City of Torrington

ADDENDUM No. 2

RE: FUESSENICH PARK EXTENSION (OAK AVENUE) DRAINAGE PROJECT PHASE 2

BID # FPD-027-022019

TYPICAL STORM DRAINAGE TRENCH
RCP NON-PAVED AREAS

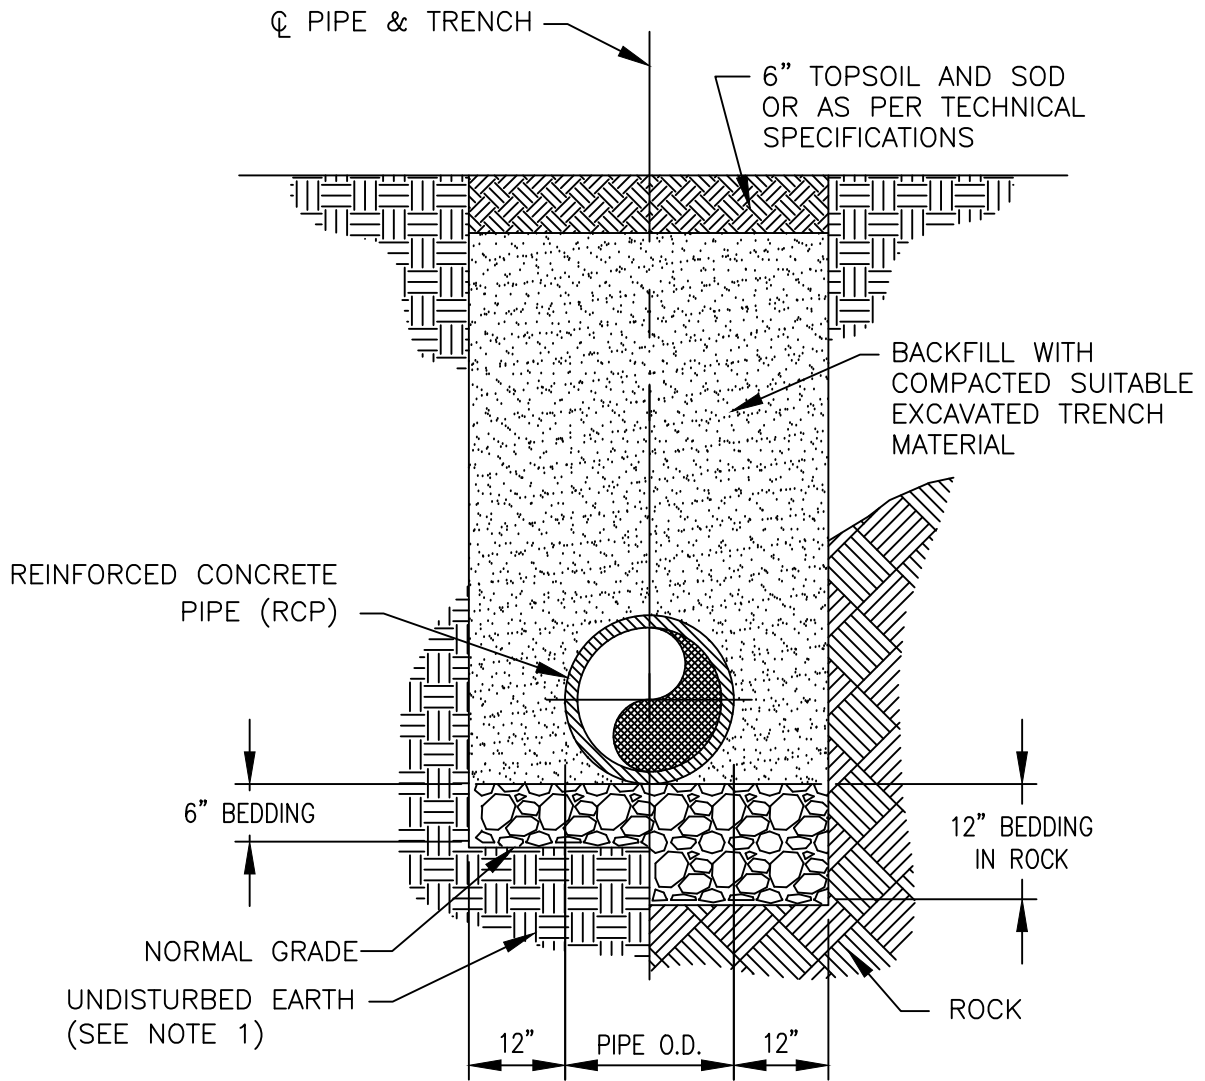
1. **ADD the attached Detail Section 4.7 "TYPICAL STORM DRAINAGE TRENCH RCP FOR NON-PAVED AREAS" noted as ISSUED 2-12-2019 ADDENDUM 2.**
2. **REPLACE** Technical Specification **Section 2500 STORM DRAINAGE** pages 02500-1 to 02500-03 in its entirety with the attached Technical Specification **SECTION 02500 – REVISED FOR ADDENDUM 2** pages 02500-1 ADDENDUM 2 to 02500-03 ADDENDUM 2.

Q6: : Pipe replacement sheet C-001. Pipe detail. Does the 8 LF need filter fabric to extend the length of the pipe?

ANSWER Q6: Refer to Detail Section 4.7 “TYPICAL STORM DRAINAGE TRENCH RCP FOR NON-PAVED AREAS” noted as ISSUED 2-12-2019 ADDENDUM 2 and Detail 1 “STORM DRAINAGE TRENCH DETAIL FOR HDPE PIPE IN NON-PAVED AREAS” noted as “REVISED 2-11-2019”.

ISSUED 2-12-2019 ADDENDUM 2
